**DATE:** 05.20.2015  
**TO:** ProTrak  
**FROM:** Bill McDow  
Transportation Planning

■ **RIVERLIGHTS CONVENTIONAL SUBDIVISION PHASE 1 [TRC Plan Review]**

↻ Initial Review Note ↻

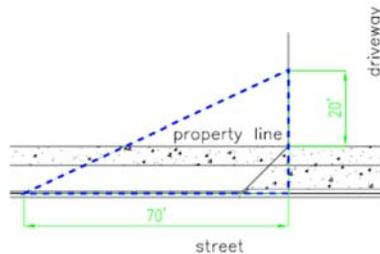
- The Subdivision Plan has changed the number of proposed lots from 104 lots proposed for the SRB to 107 lots in this submission.
- The Subdivision Plan has added another street that was not shown on the SRB submission. [See Sheet CS-100] The Unnamed Street is located north of Shell Quarry Drive and goes to the Riverlights Lake.
- What is the plan to address the new street and new lots introduced in this submission? Will the applicant submit a variance for these changes?
